Navy Department - Office of Naval Research

FR-2974

ANALYSIS AND TYPE TESTS OF REMOTE
CONTROL-INDICATOR SYSTEMS FOR MAR,
RDR, AND RDZ RADIO COMMUNICATIONS
EQUIPMENTS

By J. W. Klotz

TRANSMISSIONITY CURVES
 POWER SUPPLY UNIT-CQC20409
 MOUNTED ON 4 BARRY LN 5220
 MOUNTINGS

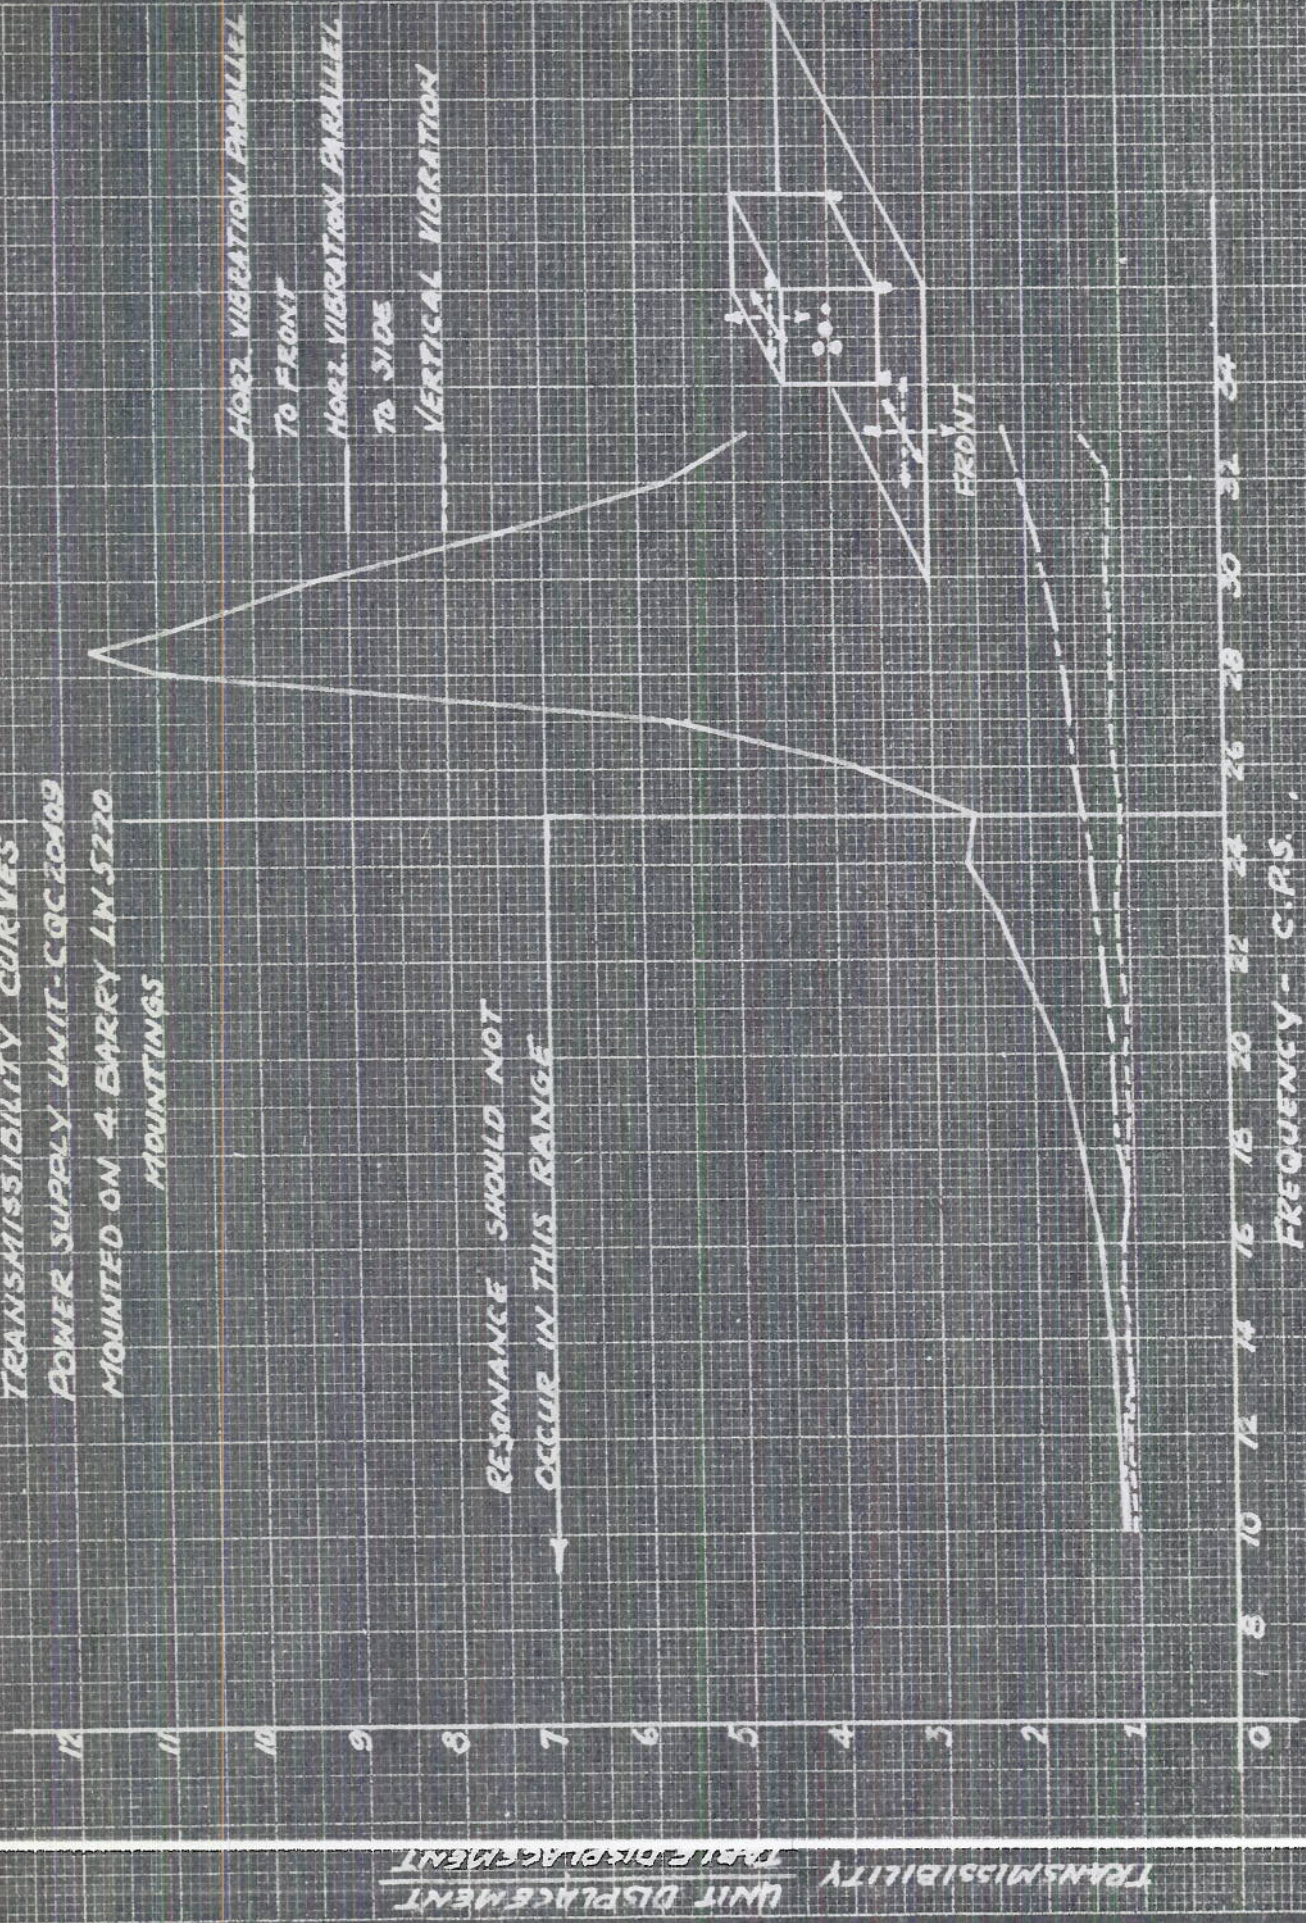
11. The Power Supply unit, mounted on 4 Barry LW 5220 mountings was vibrated along its three principal axes. The amplitude of table vibration was 0.007 inch and frequency varied from 10 to 33 cps to obtain data for the transmissibility curves, see enclosure (C).

20. The Barry LW 5210 mounts should be replaced with Barry LW 5220 mountings.

TRANSMISSIBILITY CURVES
 SELECTOR CONTROL INDICATOR
 MOUNTED ON 4 BARRY L.W. 5220
 MOUNTS

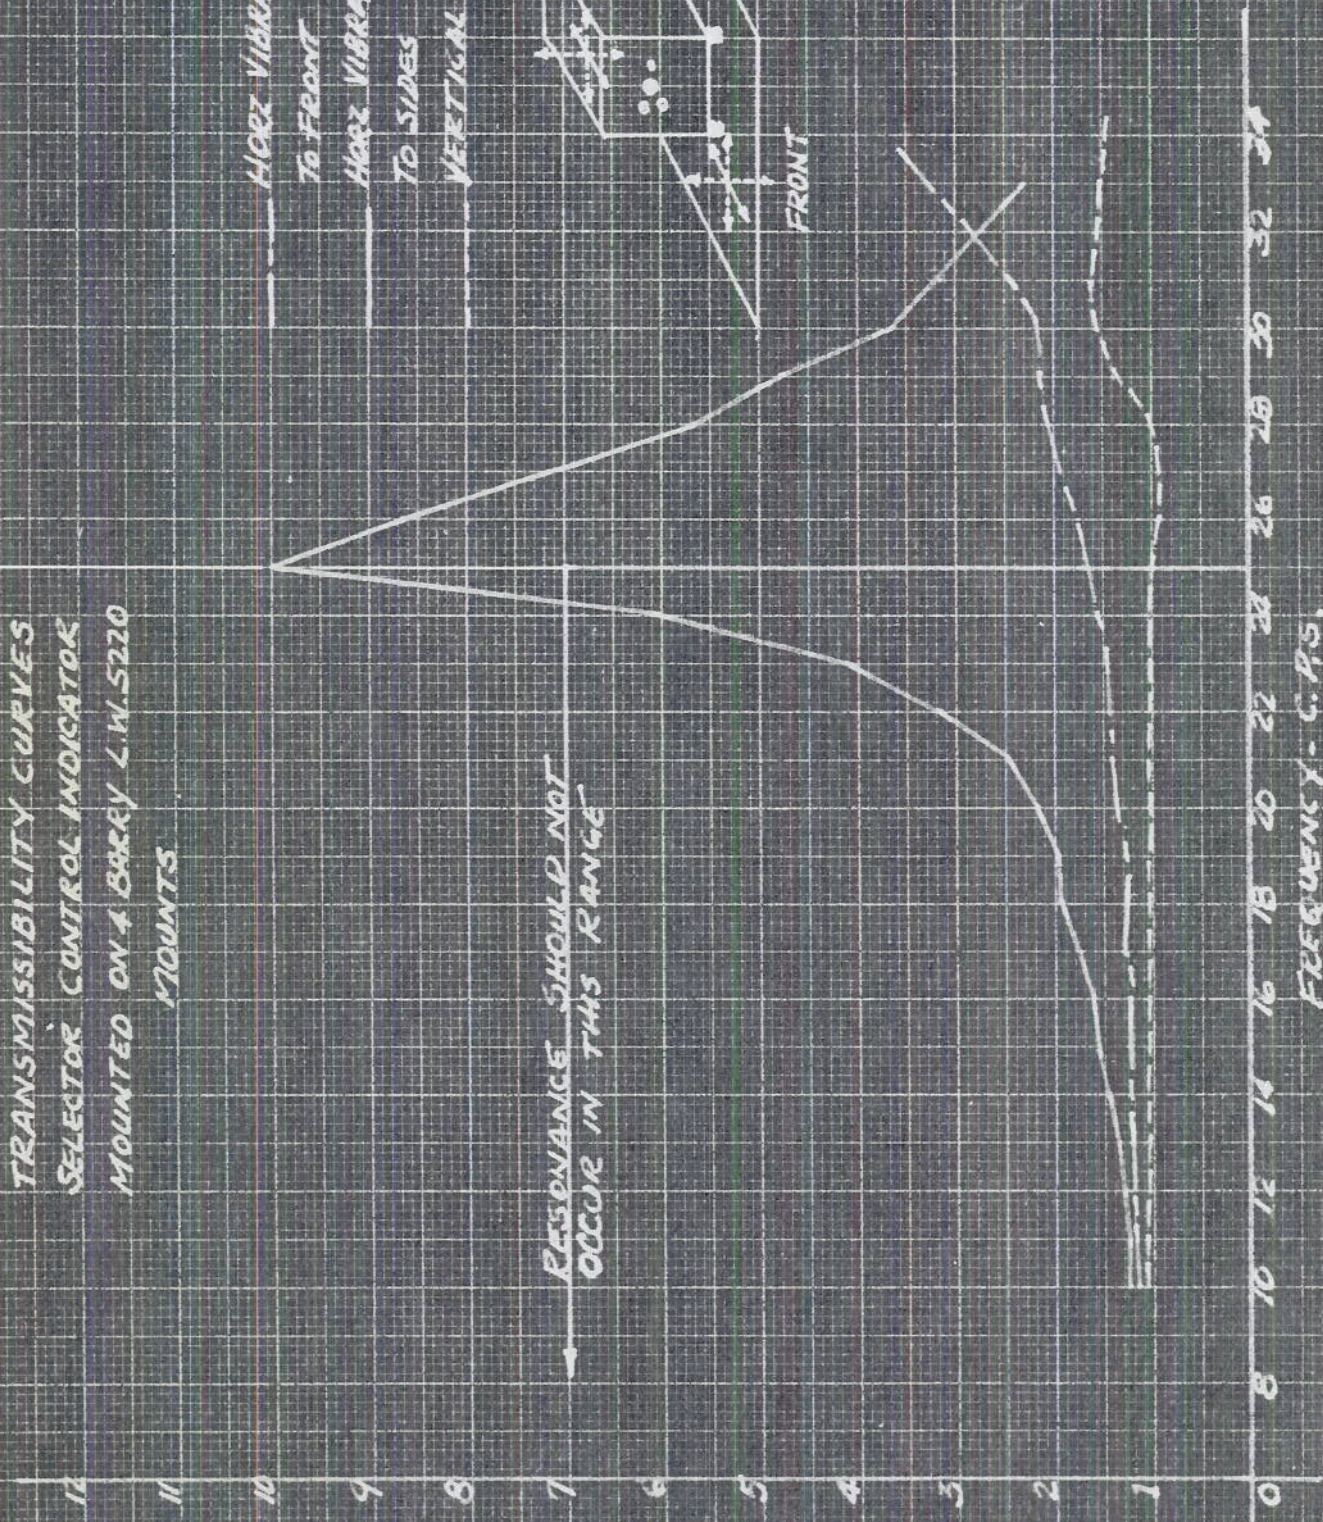
9. The modified Selector Control unit, serial #3 and the Remote Control Selector were mounted on the vibration table at the same time. The Selector Control unit was mounted on 4 Barry LW 5220 mountings and the Remote Channel Selector was rigidly mounted to the table. These equipments were subjected to vibration along their three principal axes. The amplitude of vibration was 0.007 inch and the frequency varied from 10 to 33 cps to obtain data for the transmissibility curves, see enclosure (D).

19. The Selector Control units should be modified as per serial #3 unit.

PLATE 6

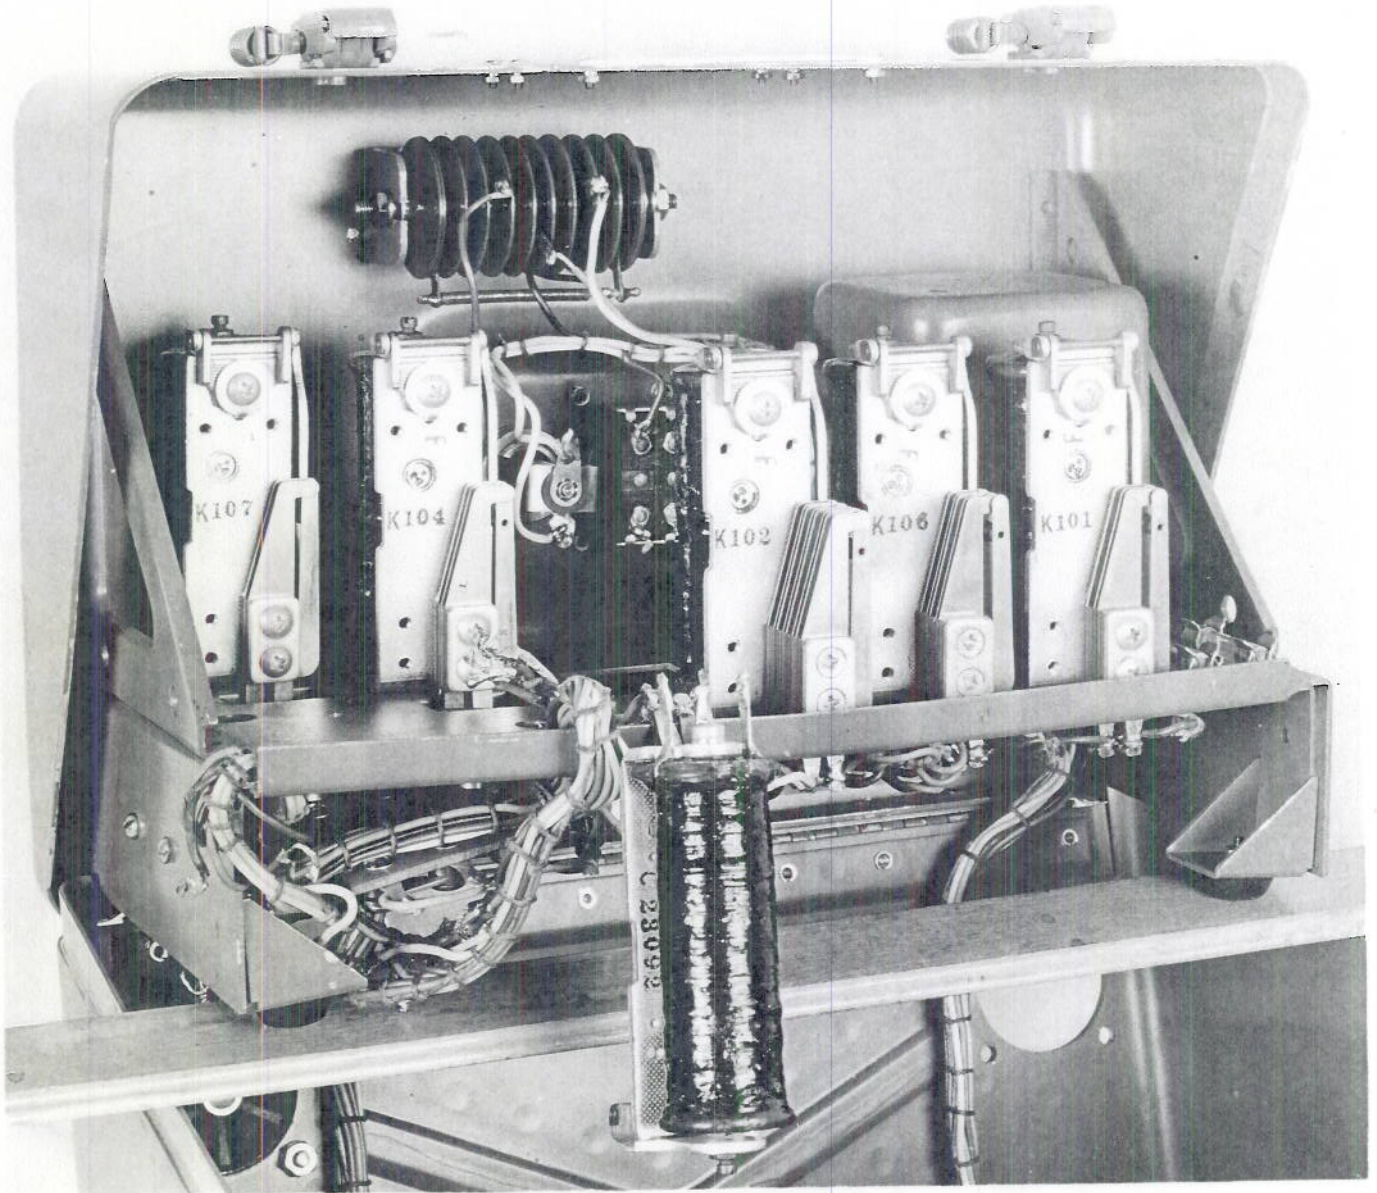
8. Tests were made to determine the effectiveness of the r-f filter block in the Selector Control Unit (see Plate 6). These filters are inserted in all of the lines connecting the Selector Control Unit and the associated receiving equipment (with the exception of the ground line carried in the interconnecting cable). It was assumed for the tests of these filters that all voltages would be generated external to the Selector Control Unit, either as a result of the interconnection of the associated Model TDZ transmitter through the Radiophone Unit, or as a result of strong r-f fields which would generate voltages on the lines leading to the Selector Control Unit.

12. In order to determine the effectiveness of the filter block, it was removed entirely from the equipment, and the various lines of the filter were connected. A similar set of measurements were taken, as described above, with the results shown in Plate 18. From this data, it is observed that the filter block in the Selector Control Unit is contributing little to the total attenuation of the system (cable, RDZ filters, RDZ circuits, etc.). The slight additional attenuation obtained for a few frequencies, and the apparent loss of attenuation at other frequencies, would indicate that the location and the design of these filters is inadequate. On the basis of these tests, the Laboratory recommended orally to the Bureau of Ships that the filters as submitted for test be eliminated from the CQC-23497 Selector Control Unit.

(c) The r-f filter networks in the CQC-23497 Selector Control Unit as submitted for test be eliminated from the unit (see paragraph 12).

FRONT VIEW, TYPE CRV-43067 REMOTE CONTROL ADAPTER MOUNTED ON COVER PLATE OF MODEL MAR RADIO EQUIPMENT. CABLE CONNECTORS TO MODULATOR UNIT AND SELECTOR CONTROL UNIT (RIGHT SIDE OF ADAPTER); "LOCAL-REMOTE" SWITCH (FRONT PANEL OF ADAPTER)

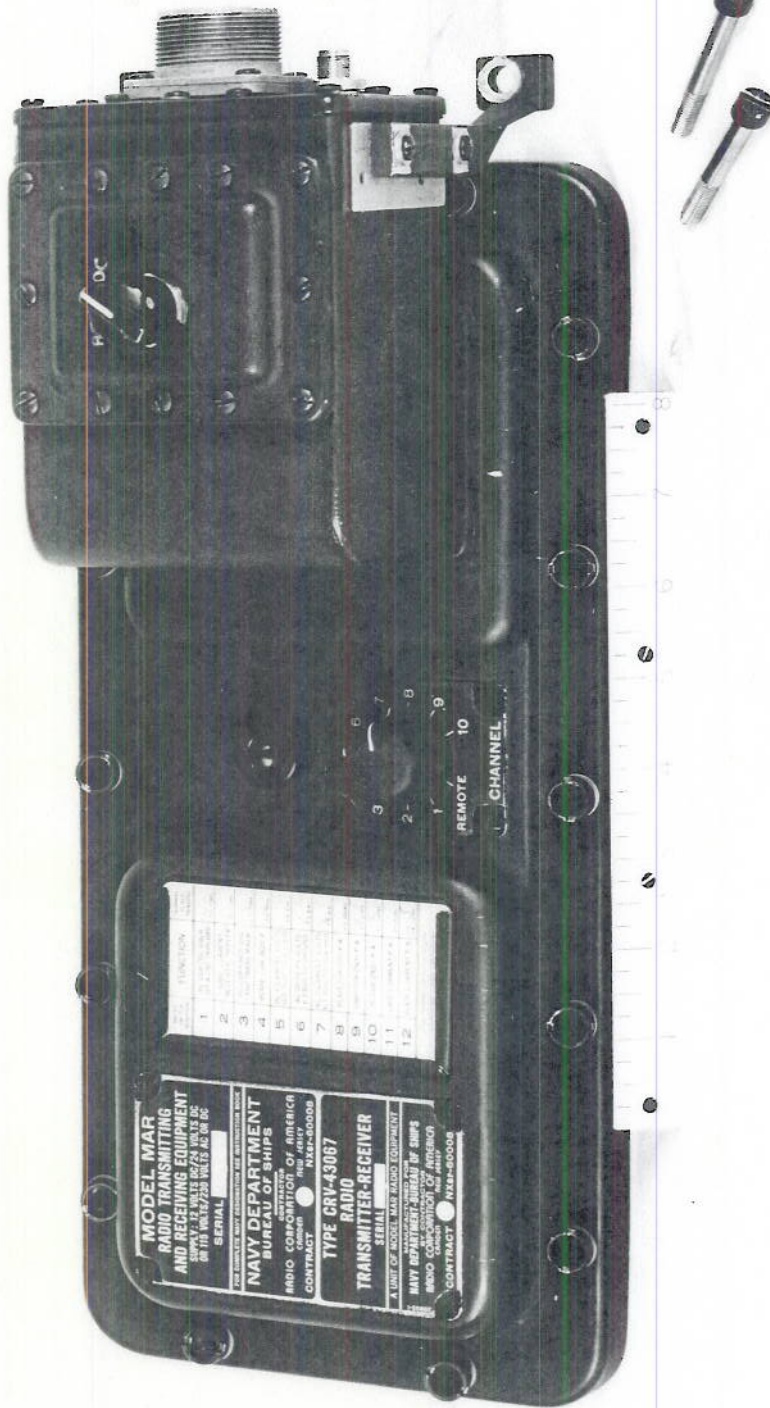
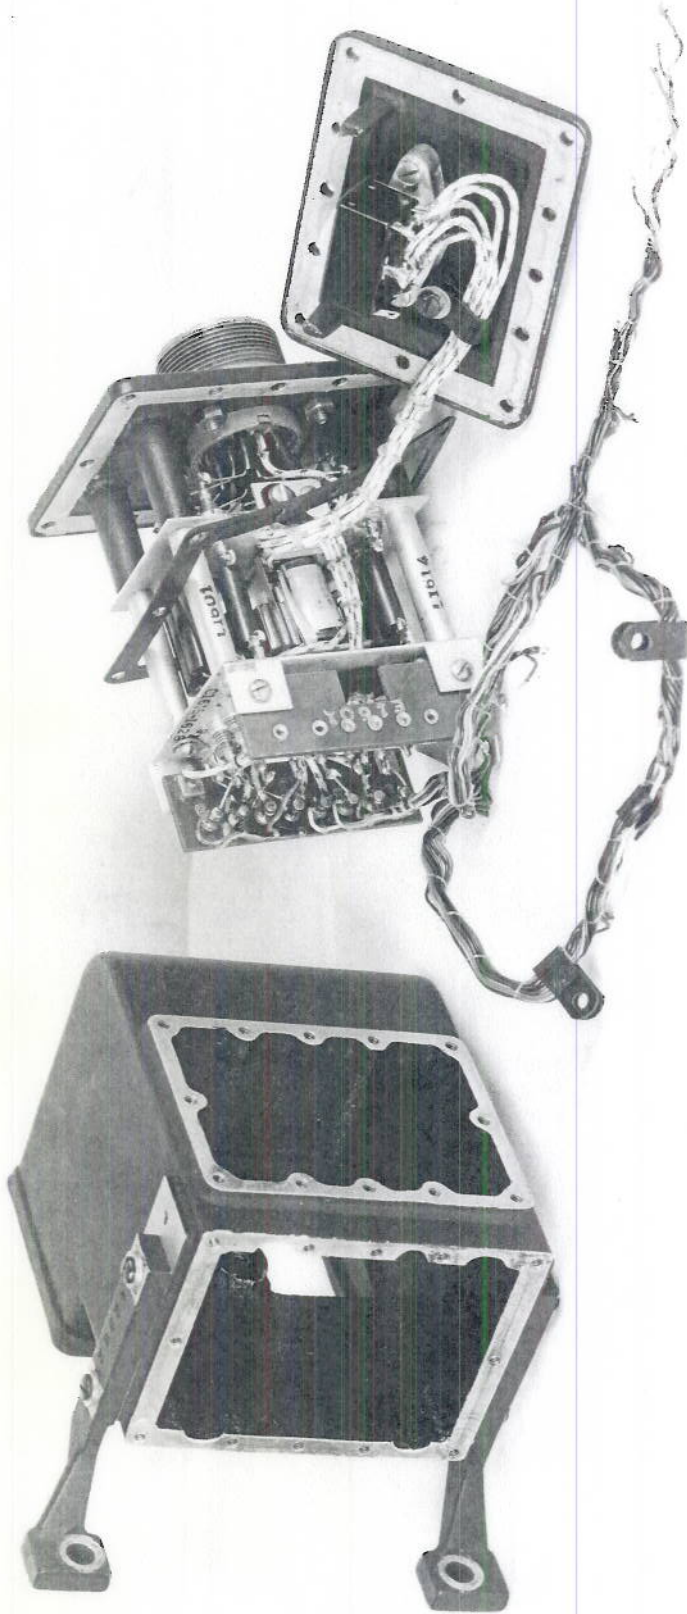
- (a) The fifteen cabled leads, which connected the Remote Control Adapter and the MAR/RDR equipment, are subjected to considerable strain and wear due to the position of the adapter on the MAR/RDR cover-plate. The Laboratory has recommended that a rubber or plastic covered fifteen-wire cable be used in place of the cabled leads. In addition, sufficient clamps of a suitable character should be provided to secure the conductors to the cover-plate, adapter, and receiver units.

- (b) After the installation of the Remote Control Adapter on the MAR/RDR equipment, the cover-plate, adapter, and receiver (see Plate 15) become a unit, and the cover-plate can no longer be laid aside while adjusting the Autotune assemblies. After the cover-plate is unfastened, its weight, and the weight of the adapter is supported by the fifteen cabled leads, which produces excessive strain on the cable. It is recommended that the cover-plate be supported with chains, or straps, or by other suitable means, when removed for adjustment of the Autotune assemblies.

- (c) The two brackets or supports (Manufacturer's Part Nos. M-442882-1 and M-442882-2) were approximately one-quarter inch too short, so that spacers had to be inserted between the supports and the MAR front cover before fastening with the two cap screws. This may be due to a variation in dimension on some of the early MAR equipments. The Laboratory has advised the Bureau of Ships of this condition.

R-F ISOLATION CHARACTERISTICS OF RDZ RECEIVER AUDIO LINE DUE TO R-F FILTERS IN TYPE 23497 SELECTOR CONTROL UNIT

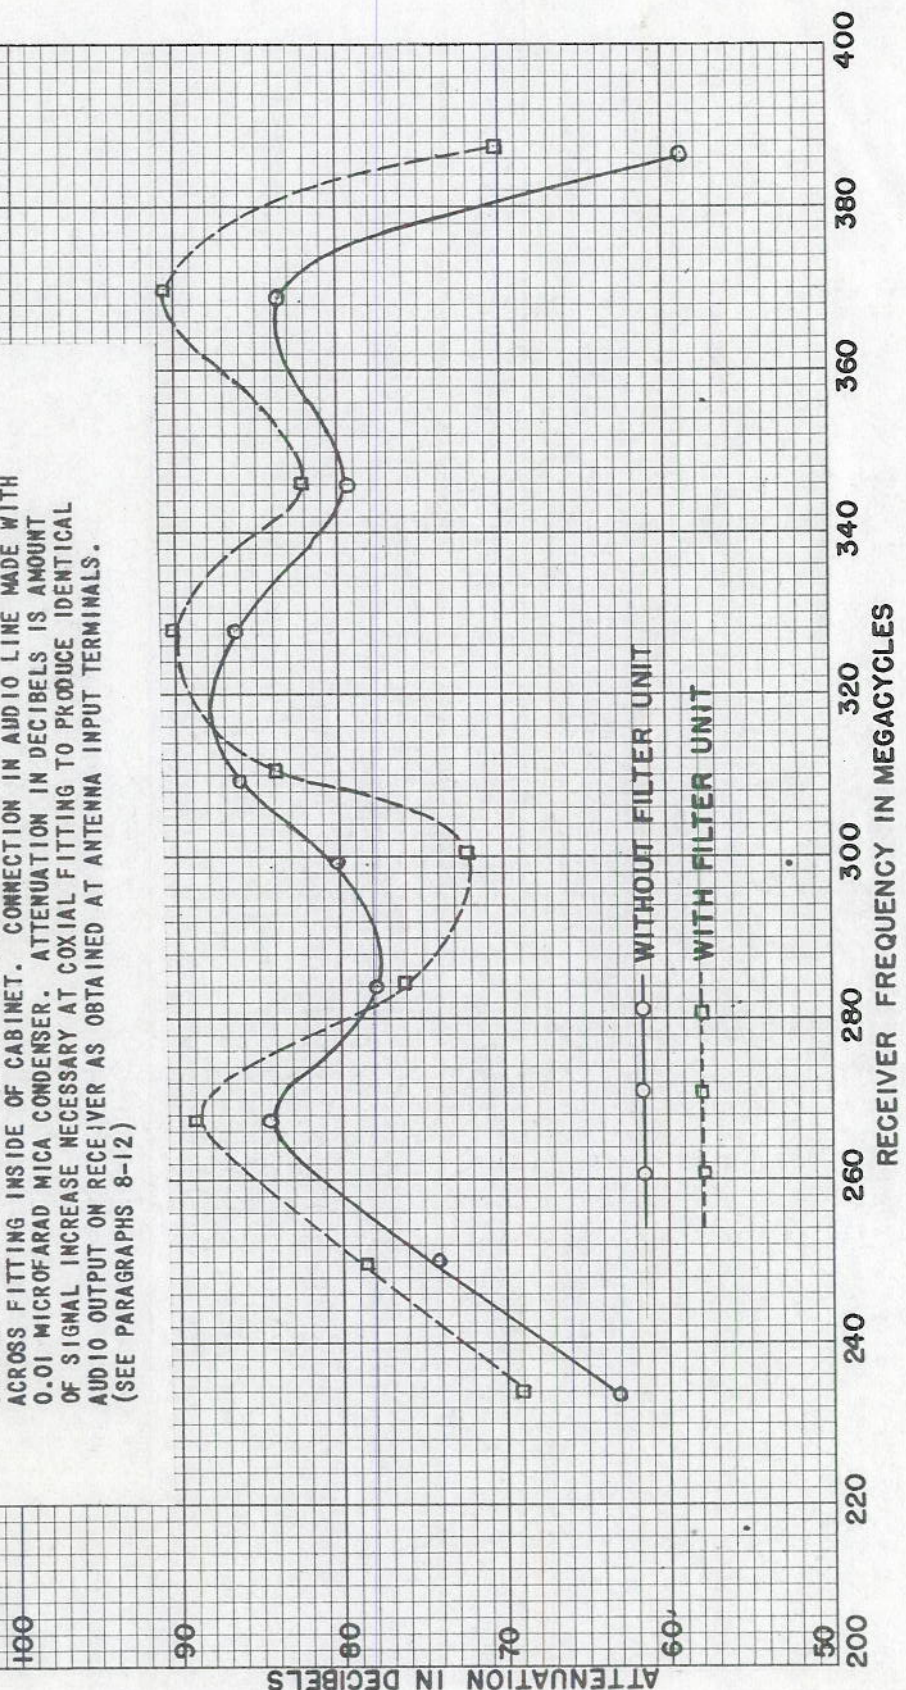
11. The total attenuation of the system on the audio lines (this includes Selector Control Unit filter attenuation, line attenuation, RDZ filter attenuation, and the attenuation presented by circuit layout in the RDZ) is given in Plate 18, in terms of the antenna sensitivity, i.e., the amount of signal (in decibels above antenna input) necessary to produce identical audio output to a signal produced by developing voltage at the antenna input. Attenuation in the order of 70 to 90 decibels was observed over a frequency range of 225-390 Mc.
